Office Action Summary	Application No. 10/597,205	Applicant(s) HELDBERG ET AL.	
	Examiner JONATHAN BRADFORD	Art Unit 3744

DETAILED ACTION

Annotated Figures**Saur**

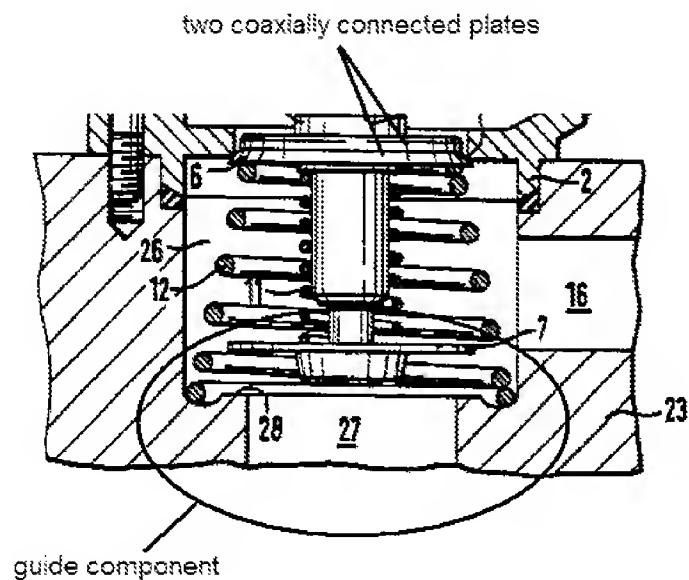
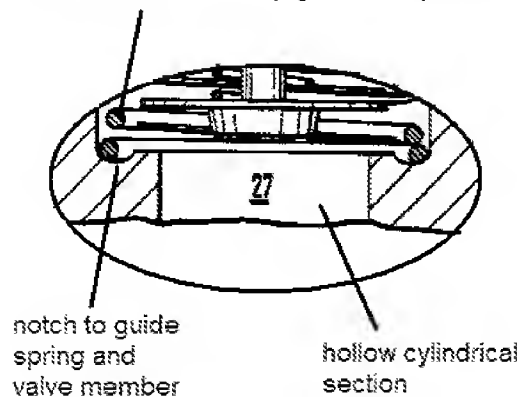
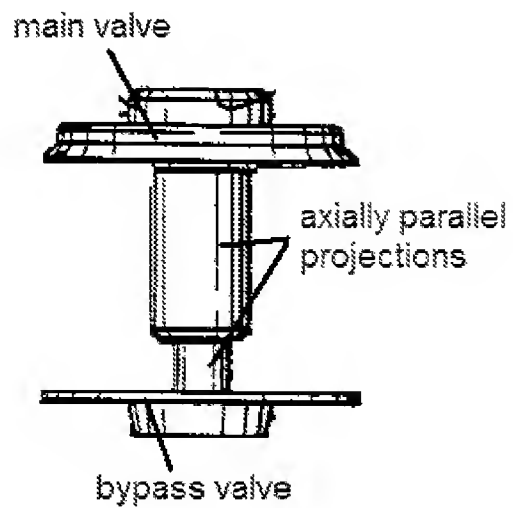
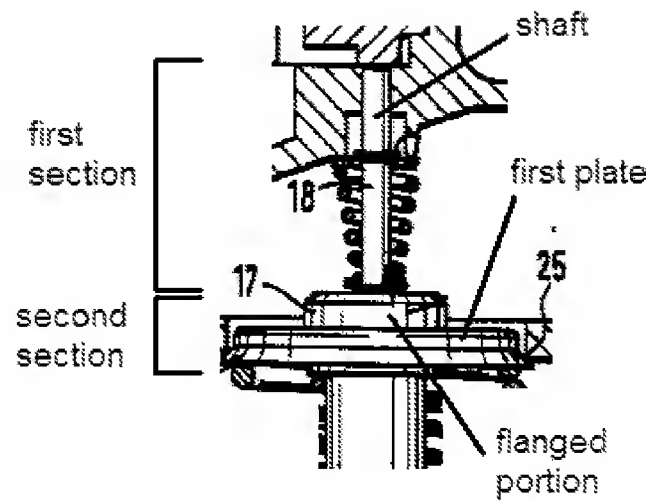
As to claim 11, Saur teaches a thermostat valve arrangement for a cooling circuit of an internal combustion engine (col. 1, lines 6-8), the arrangement comprising: a housing having a sealing valve seat 25 and formed from an upper valve housing 1 and a lower housing 23; a guide component that is a section supported by the housing and consisting of a notch holding a spring 12 to guide the opening and closing of the valve as well having a hollow cylindrical section 27 (see annotated figures); a main valve member 6 moveably engaged with the valve seat 25; a bypass valve member 7 spaced from the main valve member 6 in an axial direction and movably engaged with the hollow cylindrical section 27 of the guide component; an expansion element comprising wax within the body 17 (col. 3, lines 19-20) and a piston element 18 having a first section and a second section, the first section cooperable with an abutment fixed to the housing (col. 4, lines 1-5) and the second section cooperable with the main valve member 6 and the bypass valve member 7 (col. 4, lines 6-13) in an axial direction of the main valve member such that the valves are opened and closed to produce the cooling circuit of the engine; and a valve spring 12 between the main valve member 6 and the guide component and surrounding the expansion element and guide component (see annotated figures), wherein when the main valve member 6 is closed, the main valve member is biased by the valve spring 12 to be directly engaged with the main valve seat 25 and the bypass member 7 is disengaged from the hollow cylindrical section of the guide component (as shown in Fig. 1), and when the main valve member 6 is open, the

Saur does not explicitly teach that the main valve seat 25 is a conical valve seat. However, Henschel teaches a conical valve seat for a valve member (see annotated figures.) Since the main valve member 6 of Saur is of a conical shape, it would have been obvious to a person having ordinary skill in the art, at the time of the invention, to make the main valve seat 25 also be a conical shape similar to the valve seat of Henschel, because it would result in a larger sealing surface area between the valve 6 and the seat 25, resulting in a more effective seal that would be resistant to leakage..

As to claim 14, Saur, as modified, teaches an expansion element with a shaft 18 at the first section which faces the main valve seat, while a flanged second section is received in a complementary recess of the first plate (see annotated figures.)

As to claim 15, Saur, as modified, teaches a main valve member 6 which is connected to the bypass valve member 7 by parallel projections which extend axially (see annotated figures).

As to claim 16, Saur, as modified, teaches a second plate facing the bypass valve 7 that is connected to the bypass valve 7 via the projections and forms an integral component consisting of the second plate, the projections, and the bypass valve member 7 (Saur, Fig. 1).

spring surrounding notch and cylindrical section which make up guide component

Henschel

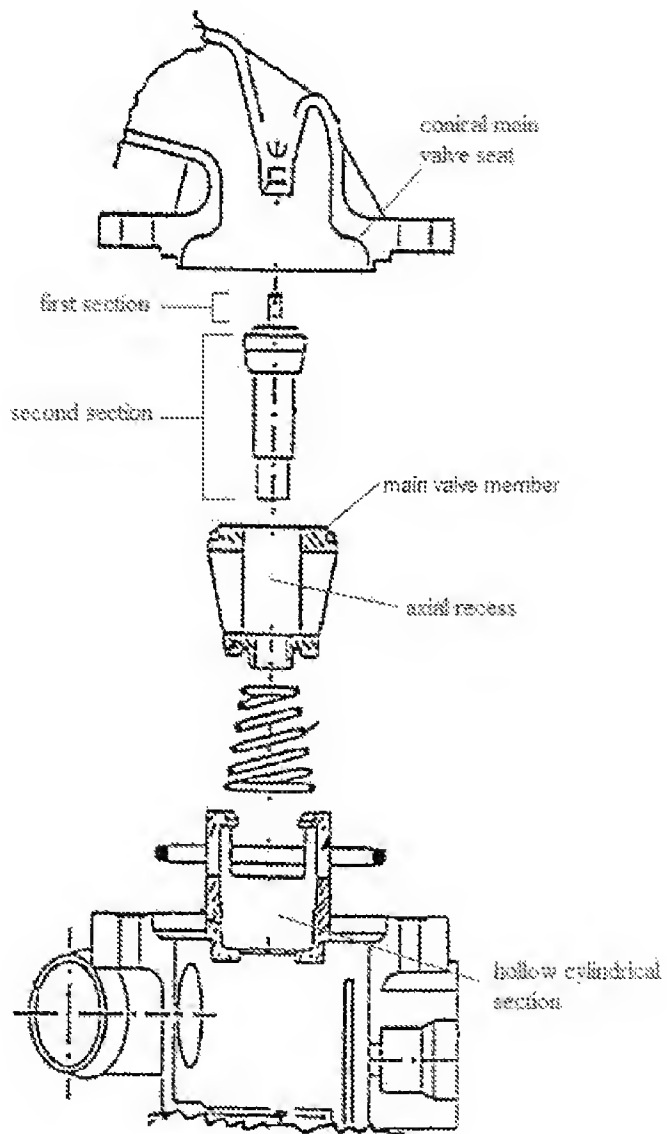
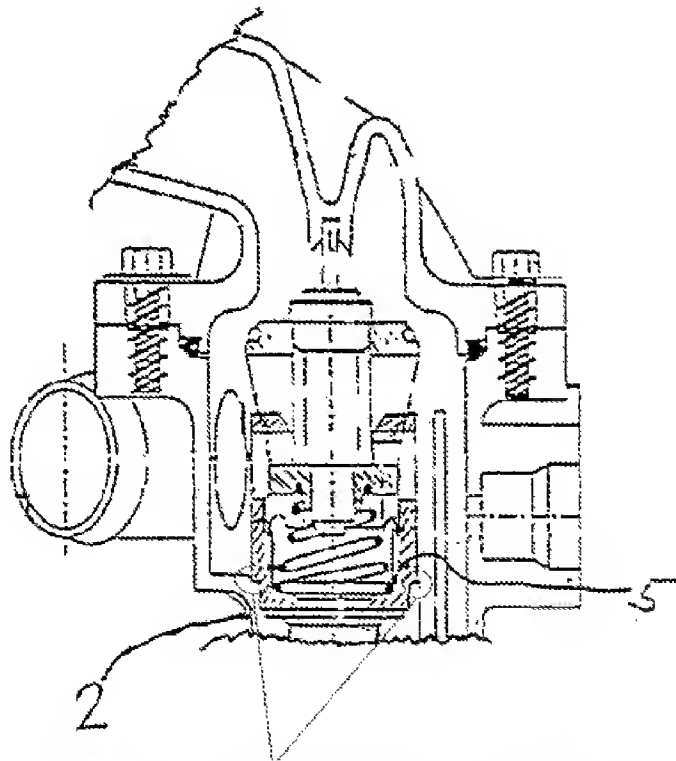
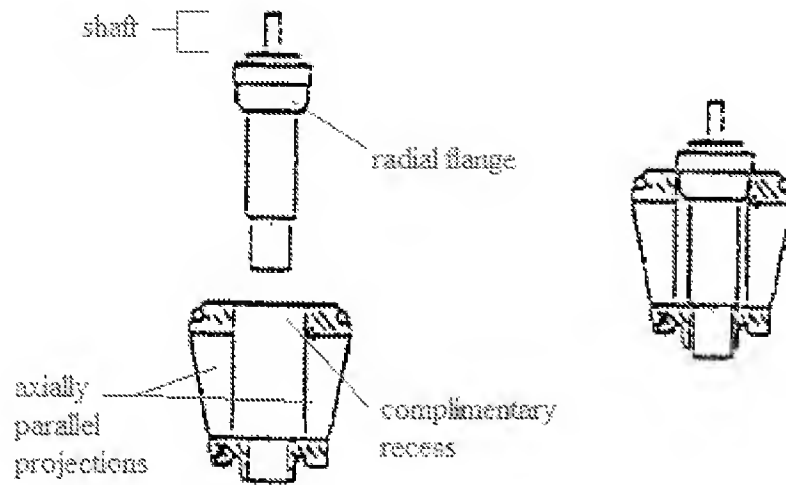
As to claim 25, Henschel, as modified, teaches an expansion element comprising a shaft at the first section facing the main valve seat and a radial flange at the second section received in a complementary recess of the valve member which faces the flange (see annotated figure).

As to claim 26, Henschel, as modified, teaches connecting the main valve member with the bypass valve member with axially parallel projections (shown in annotated figures).

As to claim 27, Henschel, as modified, includes a valve member equivalent to first and second plates as stated in the rejection of claims 23-24 above. Further, the lower portion of the main valve member (analogous to a "second plate") is connected with the bypass valve member via the projections and the elements form an integral component (see annotated figures).

As to claim 29, Henschel, as modified, teaches a guide component 5 with an internal radial flange on which the valve spring 6 is directly supported (shown in Figs. 2 and 3 of Henschel). The flange projects outwardly from the center hole at the lower end of the guide component 5.

As to claim 30, Henschel teaches a guide component 5 that has an annular rib which fits securely into an annular groove of the lower portion 2 that supports the guide component (see annotated figures).

Annular rib of guide component 5 fits securely into an annular groove of the lower portion 2 which supports the guide component.
